Notice of Allowability

09/918,886

David S. Kim

EXAMINER'S AMENDMENT

FIG. 9

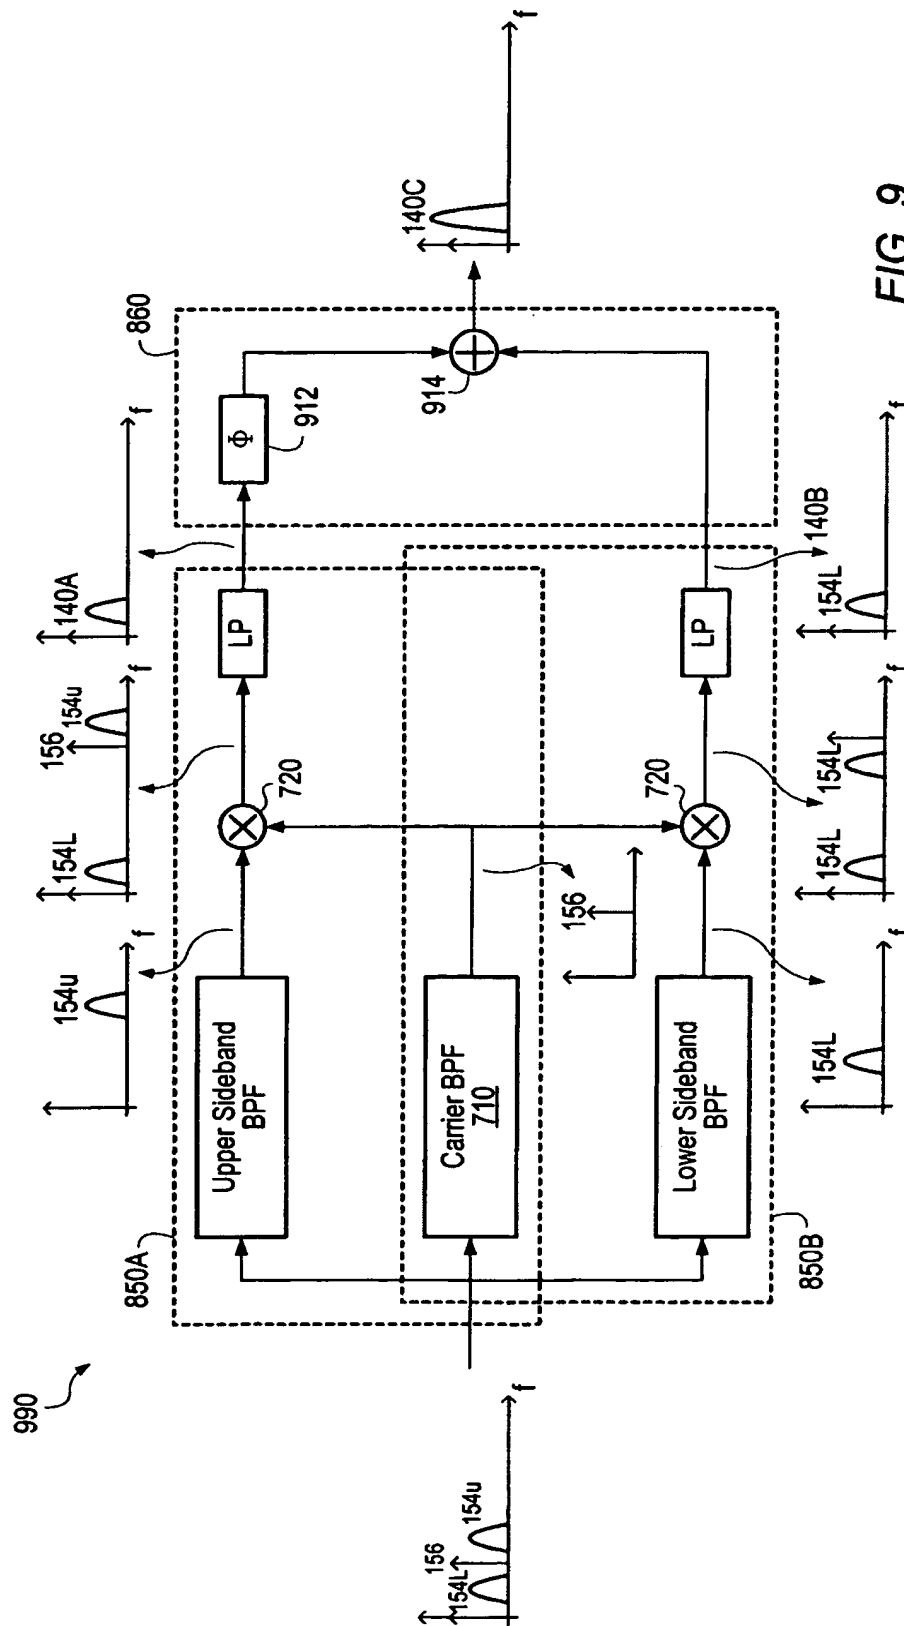
Fig. 9

In the upper half of Fig. 9, there are three spectrum graphs. In the middle graph, remove the labels “154L”, “156”, and “154u”.

In the bottom half of Fig. 9, there are three spectrum graphs. In the middle graph, remove the labels “154L”. In the right graph, remove the label “154L”.

Disapproved by DSK
14 July 2006
